Report: PRELIM
Function: Test, Adjust, & Balance
Date: 02/02/2024

PROJECT
Valvoline (Bellevue, WI)

Section	Page #
Summary	3
Issue Data	4
FAN - Exhaust	7
Split Sys Furnace	11
GRD Layout	13

2 LOWER LEVEL MECHANICAL PLAN
 M-1.1 Scale: 1/4" = 1'-0"

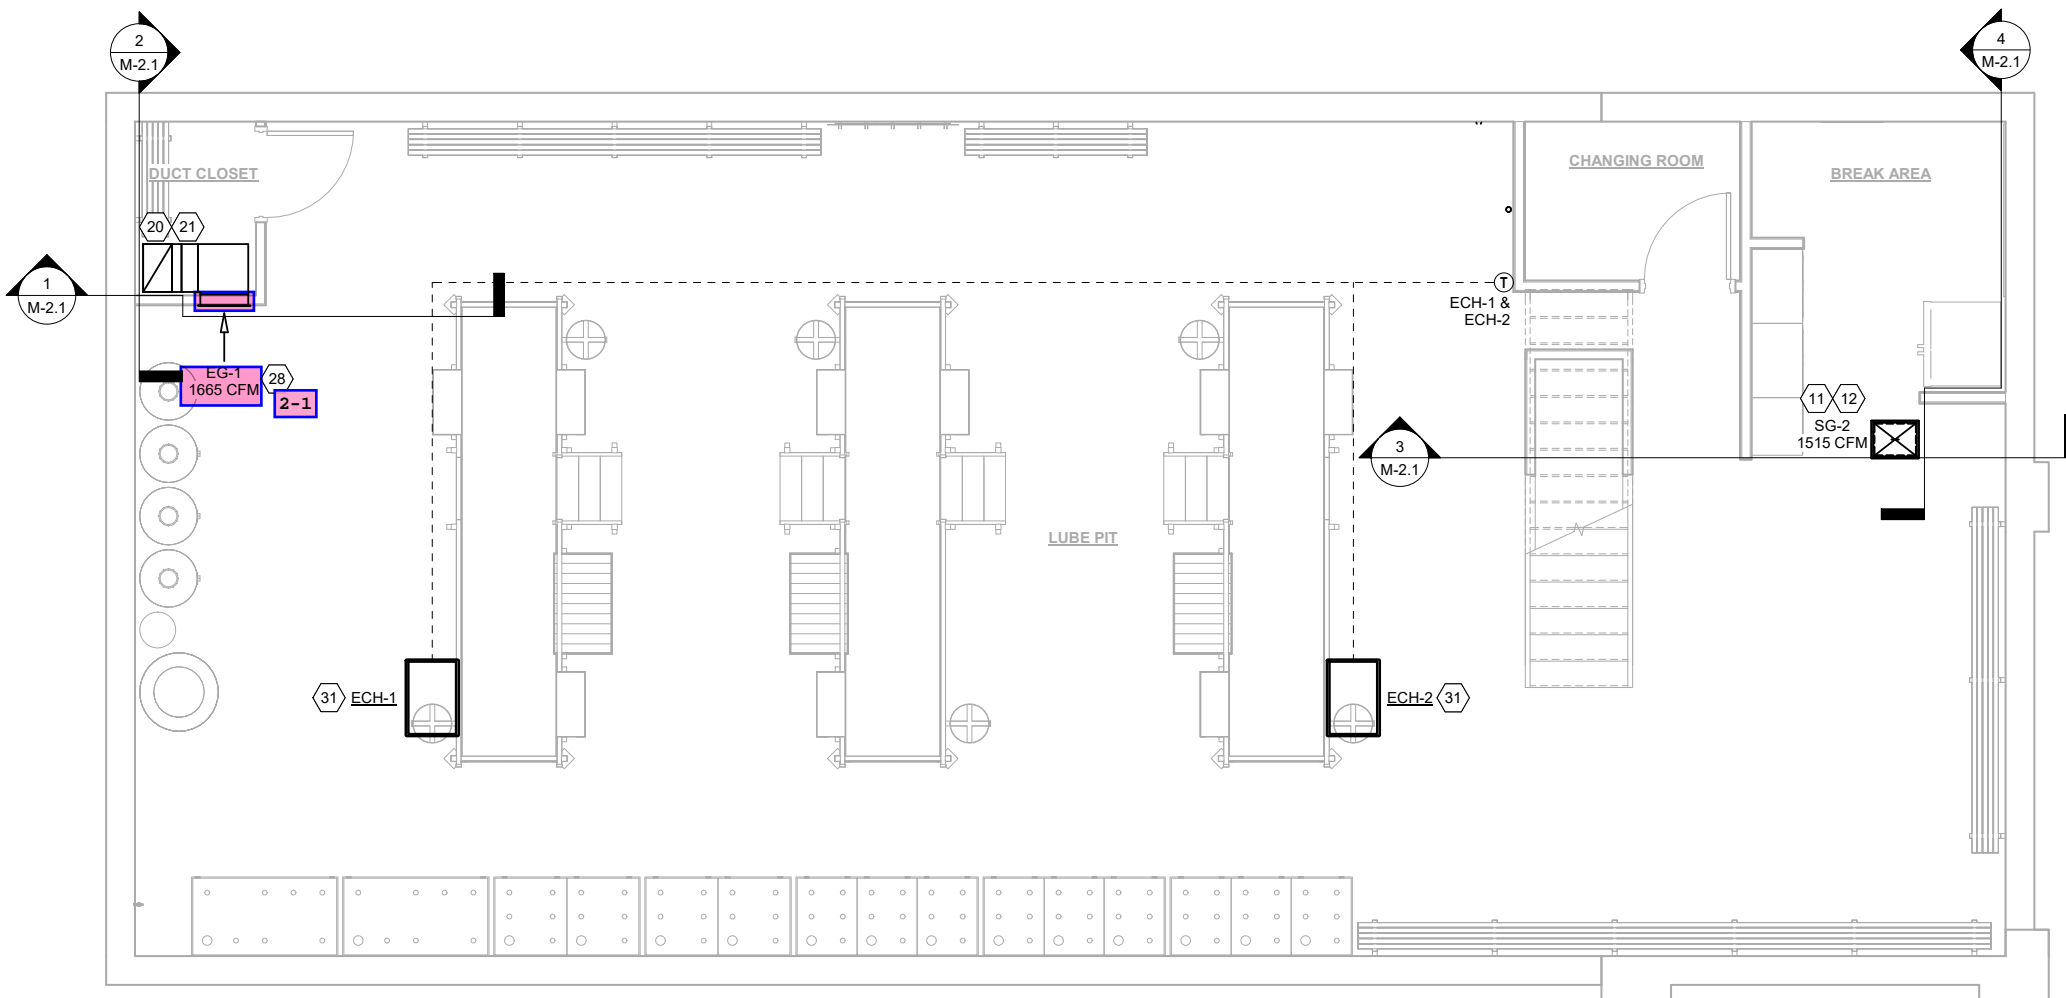
Issue Name : Return Dampers Missing
Description : Return dampers are not installed on returns 1-1 and 1-2. As a result, return airflow cannot be properly balanced. Recommend return dampers are installed.
Created By : National TAB **Assigned To :** National TAB - Michael McDonnell
Status : Open
Priority : **Asset Tag :**
Originated Date : 02/02/2024 - Michael McDonnell - National TAB

Asset	Notes	Date	Written By
Furnace1-EGRD1	[1] NO DAMPER INSTALLED	02/02/2024	Michael McDonnell
Furnace1-EGRD2	[1] NO DAMPER INSTALLED	02/02/2024	Michael McDonnell
